CHANGE ORDER NO. 11

PROJECT: West Sewage Treatment Plant (STP) Improvements  
 OWNER: City of Crest Hill, Illinois  
 CONTRACT: 1-2022  
 CONTRACTOR: Vissering Construction Company

Project: CITY OF CREST HILL - WEST SEWAGE TREATMENT PLANT IMPROVEMENTS

Cost Proposal Request  
West Sewage Treatment Plant Improvements  
City of Crest Hill  
Contract 1-2022  
August 26, 2025

SHEET  
175  
E70-ASM1.02

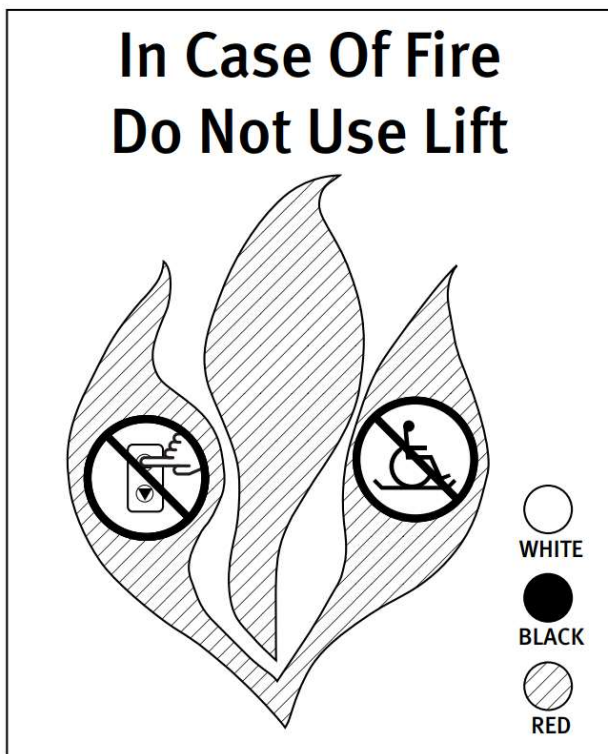
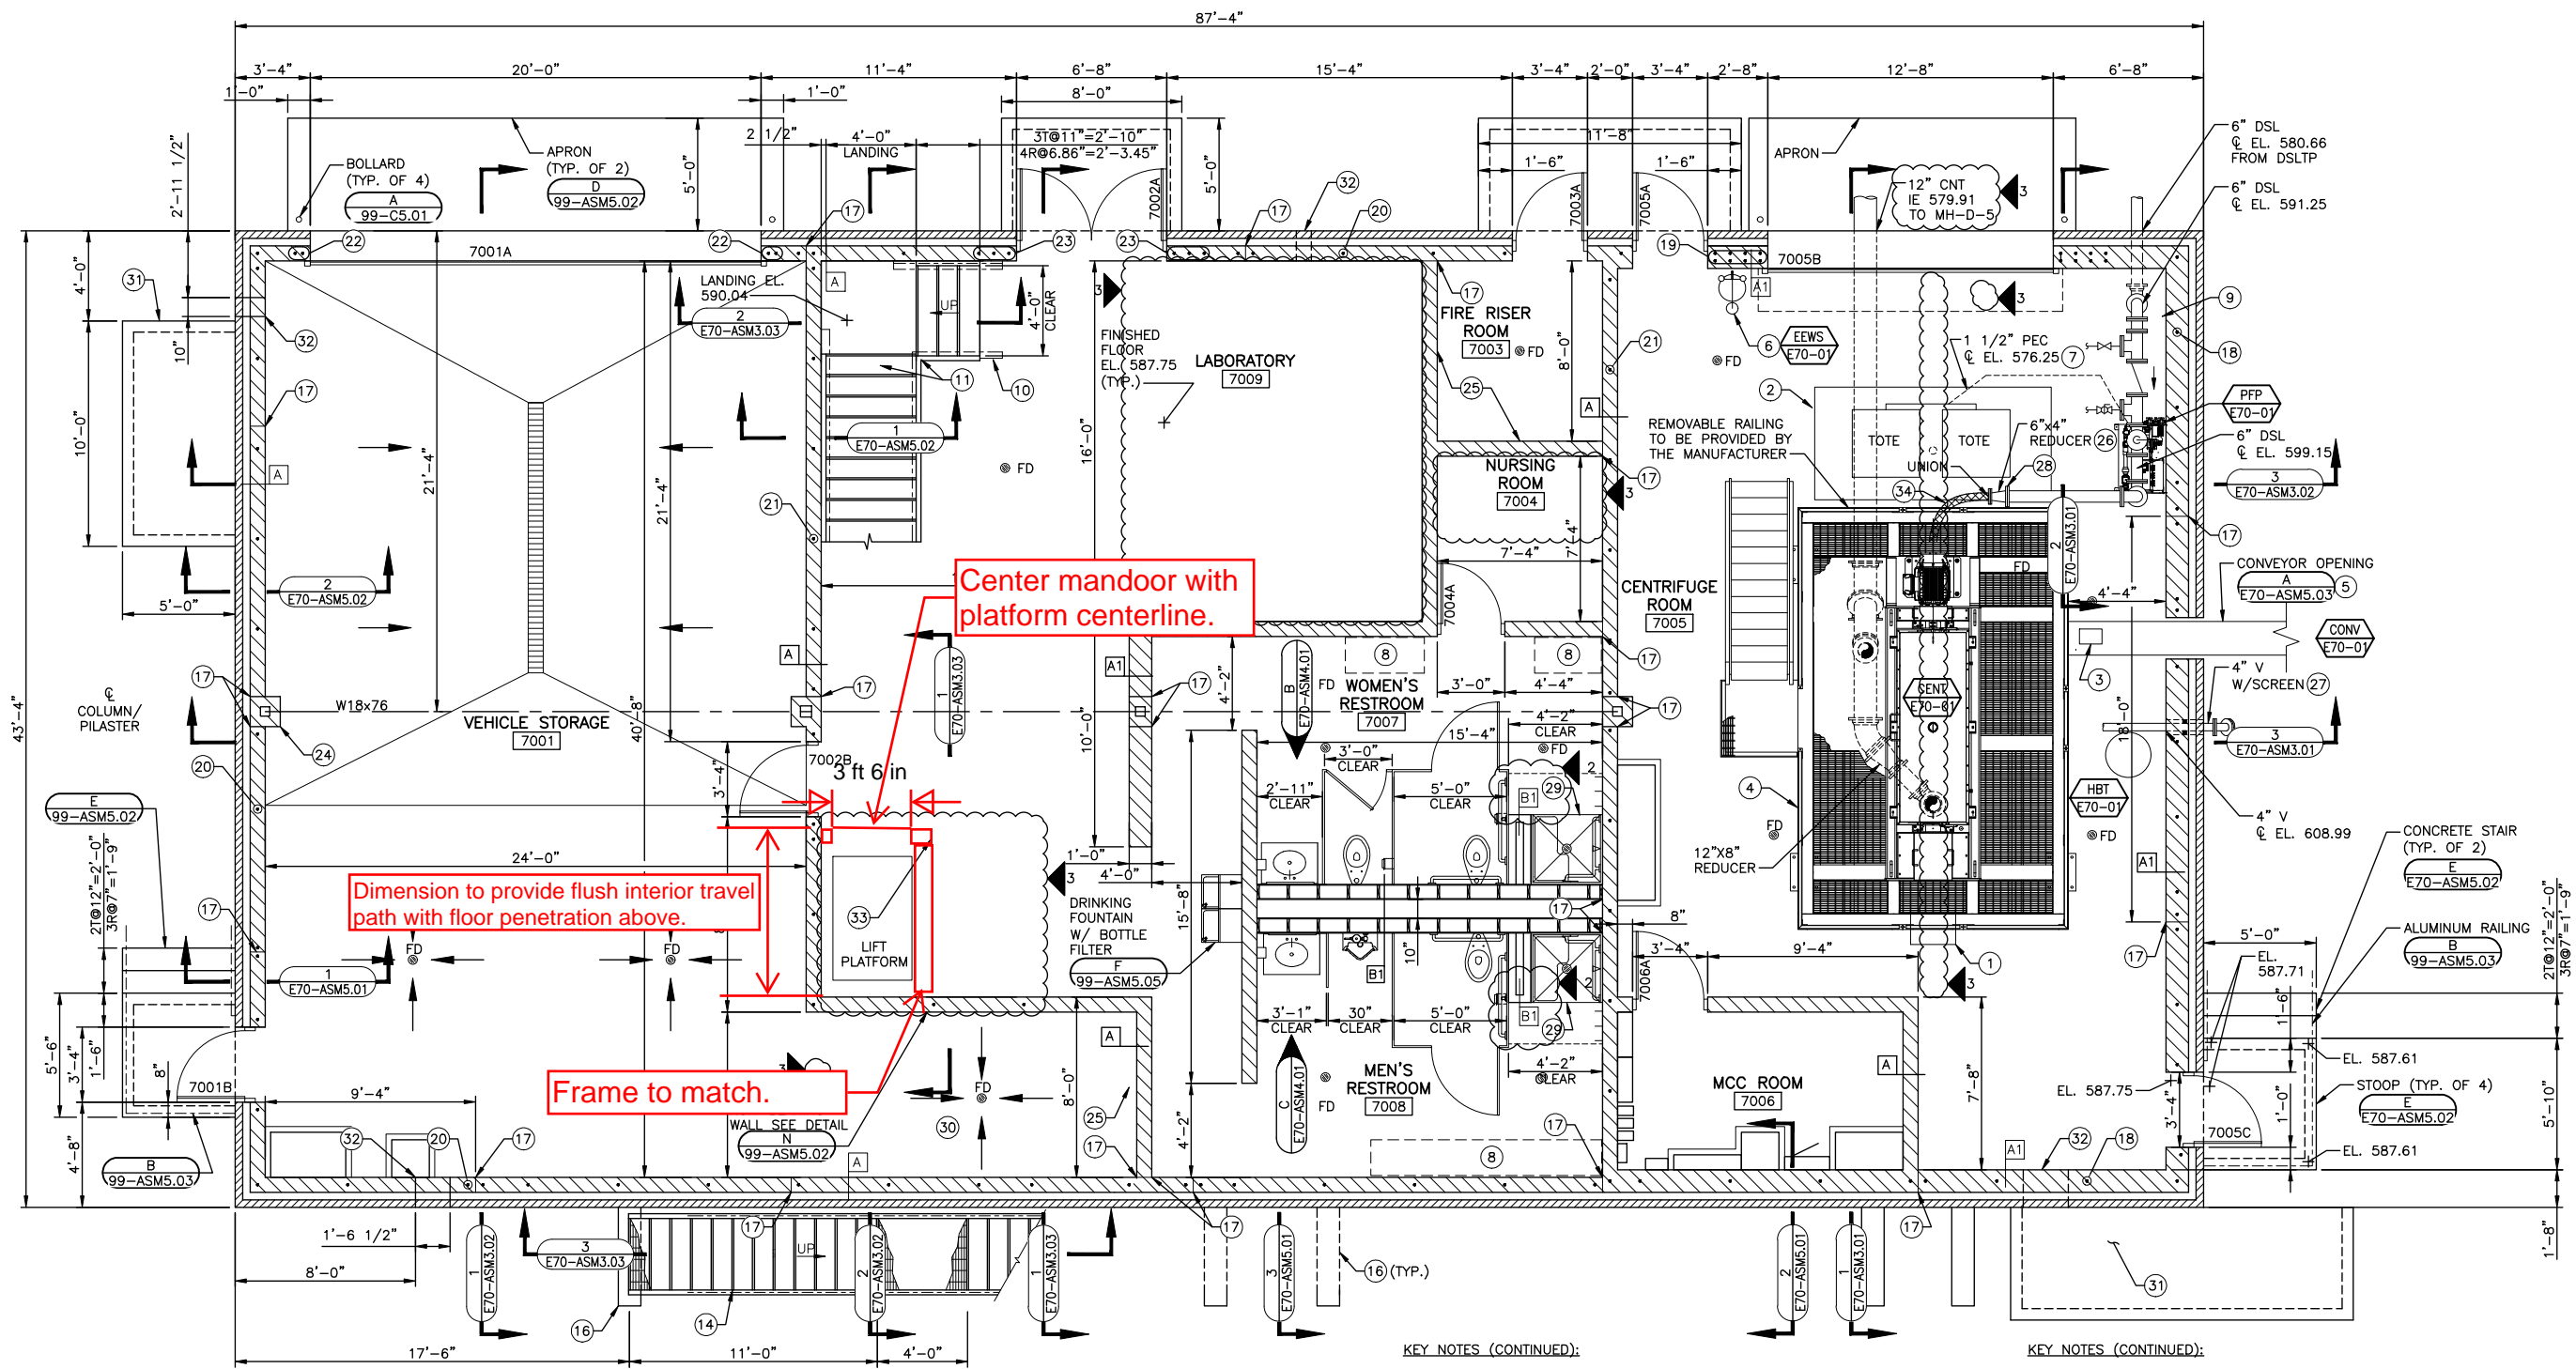
**Drawing E70-ASM1.02**

- 044-04 Frame northern shaft fenestration on second floor. See attached drawing. Standard manufacturer-provided door, its respective wiring, and call-station shall remain at the second floor.

**SHEET**  
174  
E70-ASM1.01

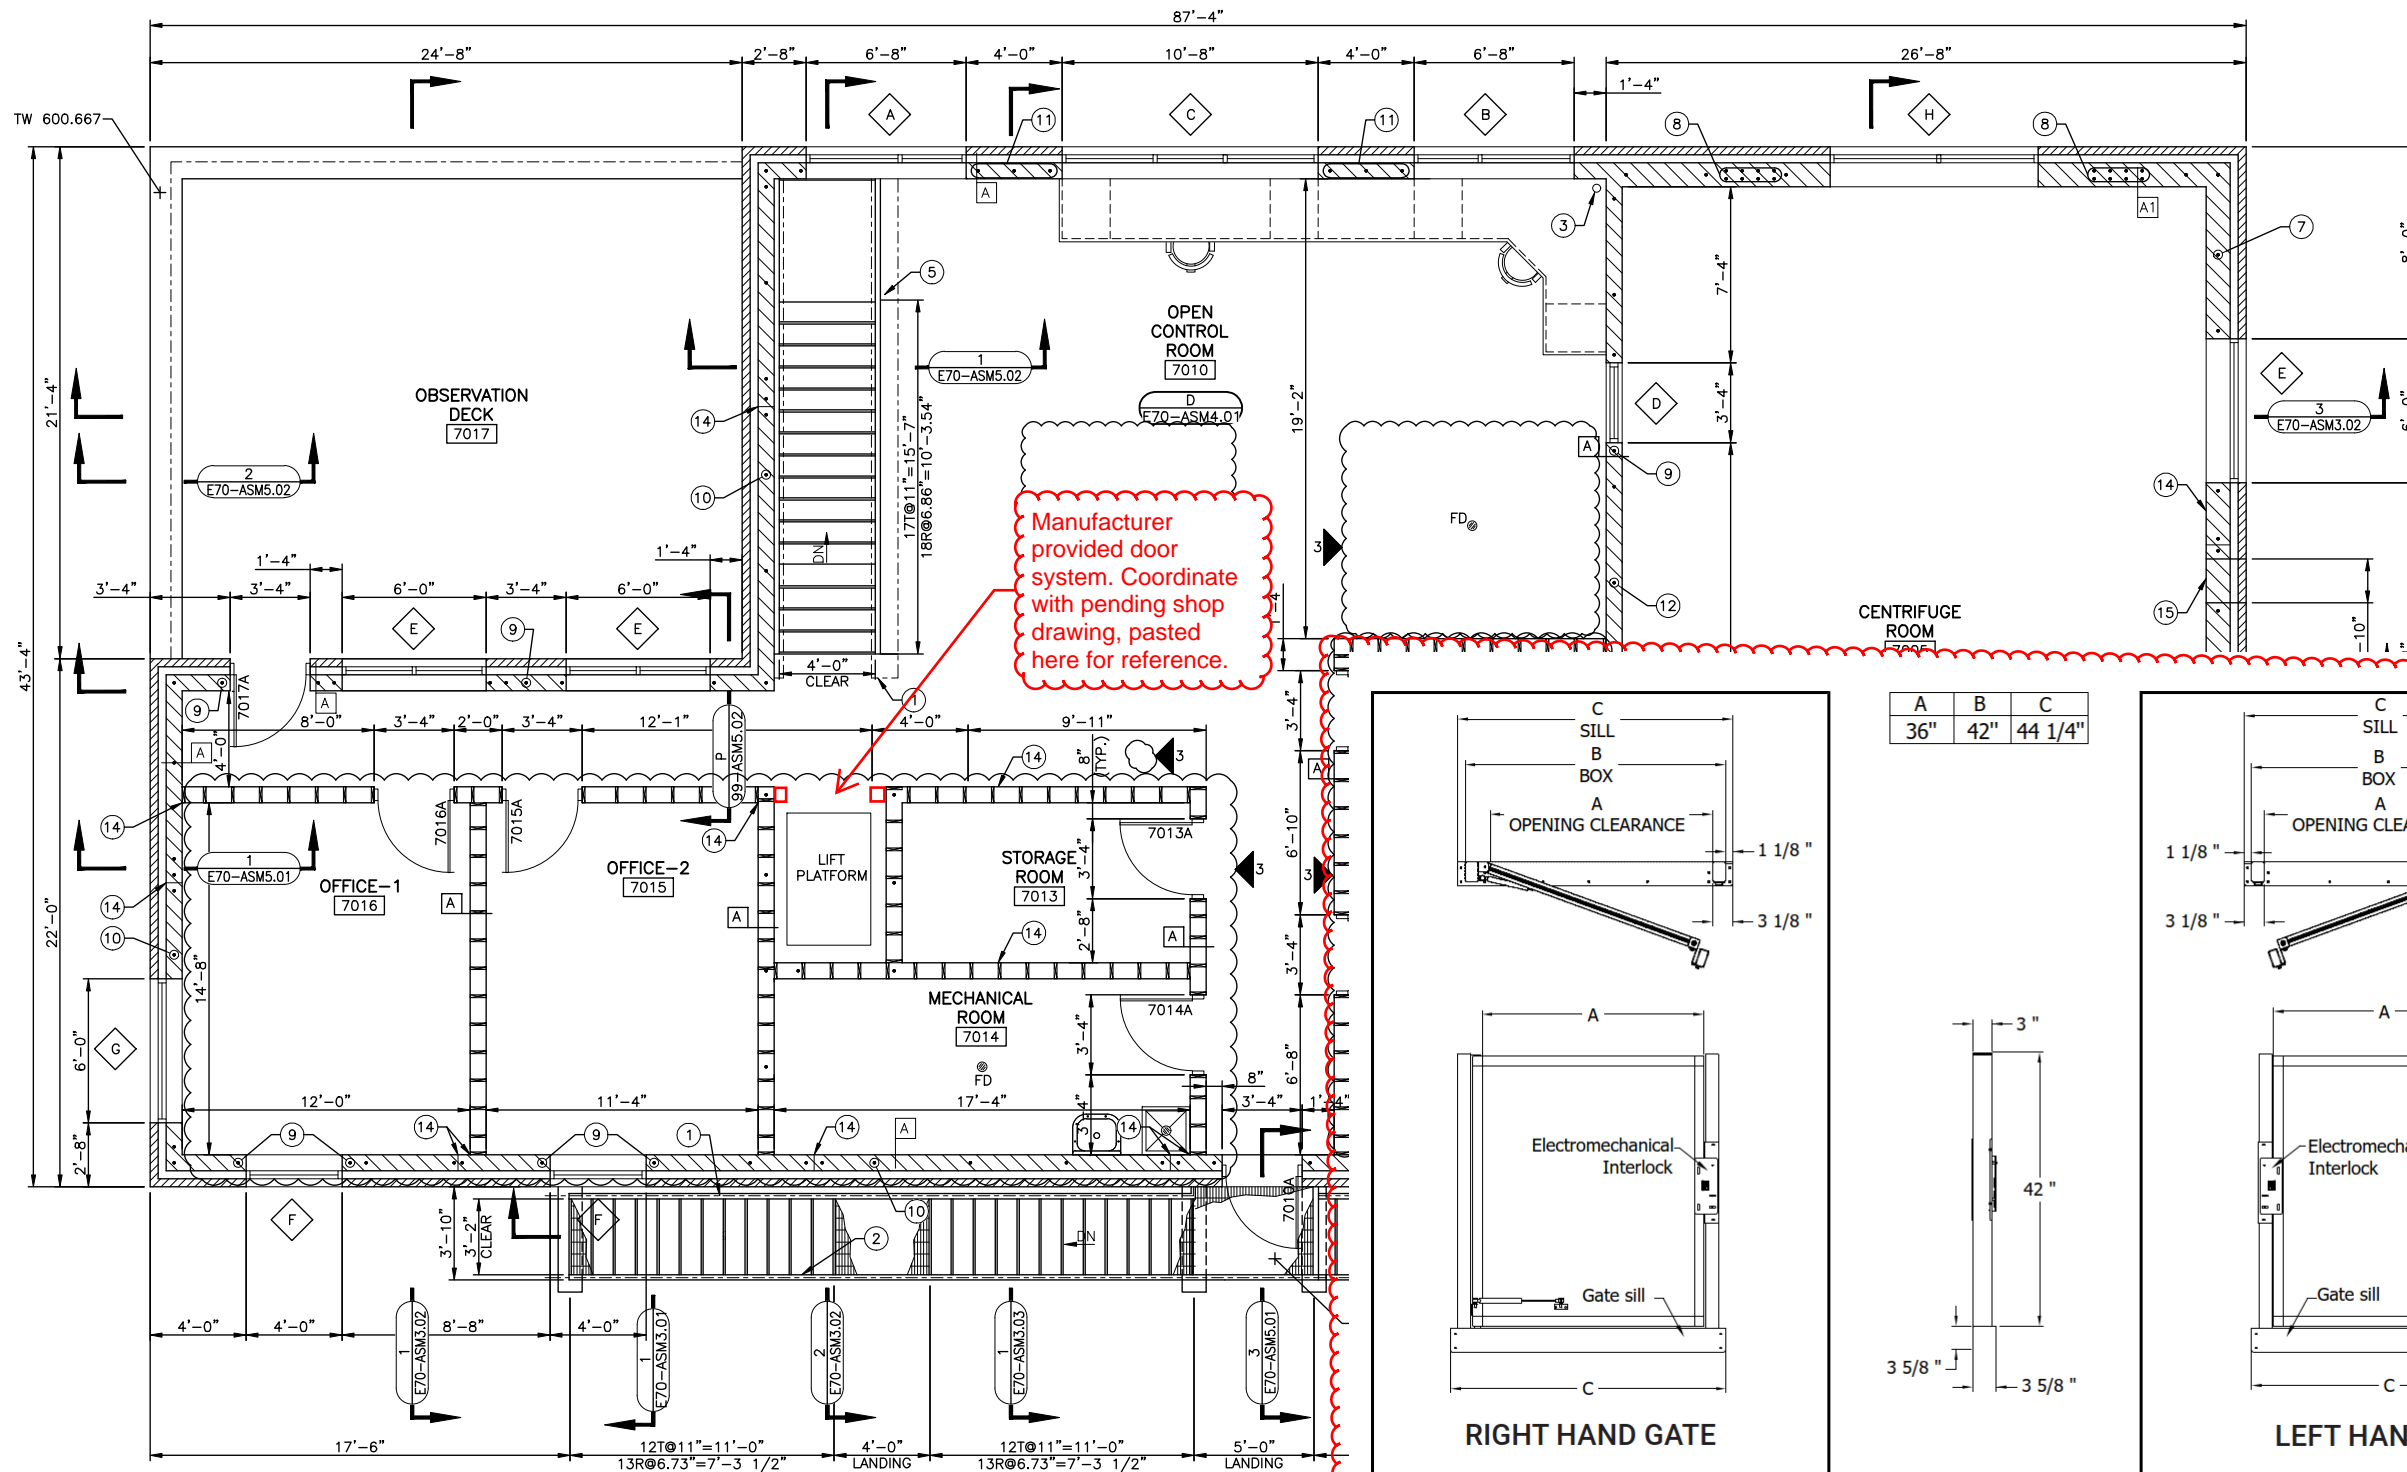
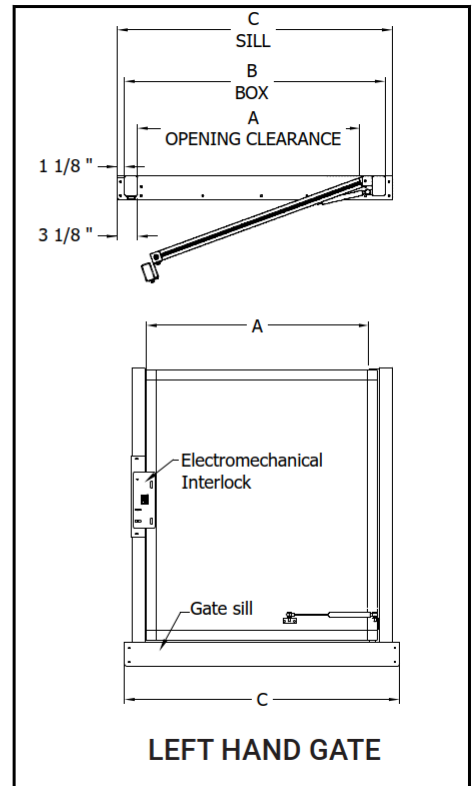
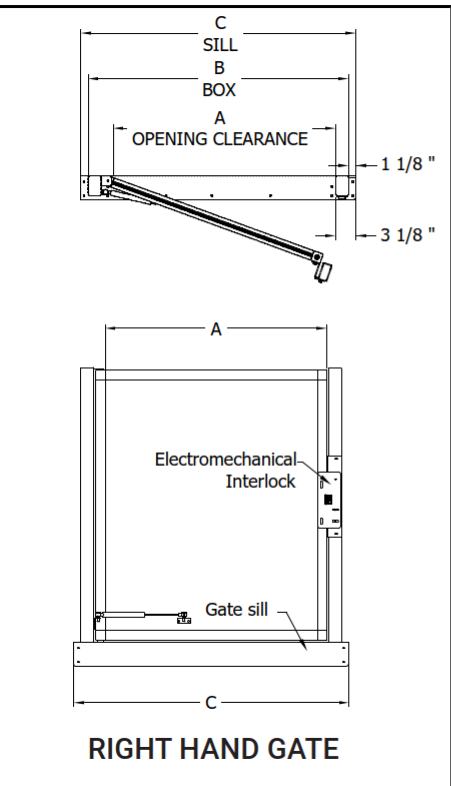
**Drawing E70-ASM1.01**

- 044-01 Frame and drywall the northern and eastern shaft fenestration surrounding the newly proposed door on the first floor. See attached drawing.
- 044-02 Change manufacturer provided first-floor half-height door with full height mandoor. Rewire electrical componentry from manufacturer-provided call-station to interlock doorway hardware (automatic door opener) with platform lift system operation, as described below.

Add row to Drawing 99-ASM6.01 Door 7002C, size 3'-6" x 7'-0", type - STL, active - HG, swing - RHR, frame type - 1, frame material - STL, hardware group - as provided by product manufacturer, active, lintel - B-1, Details, head - F-99-ASM6.02, jamb - F-99-ASM6.02, sill - N/A
- 044-03 Provide attached pictograph (Attachment A) at first floor and second floor call stations. Pictograph shall conform to Section 10 14 00 - Plastic and Metal Signs.
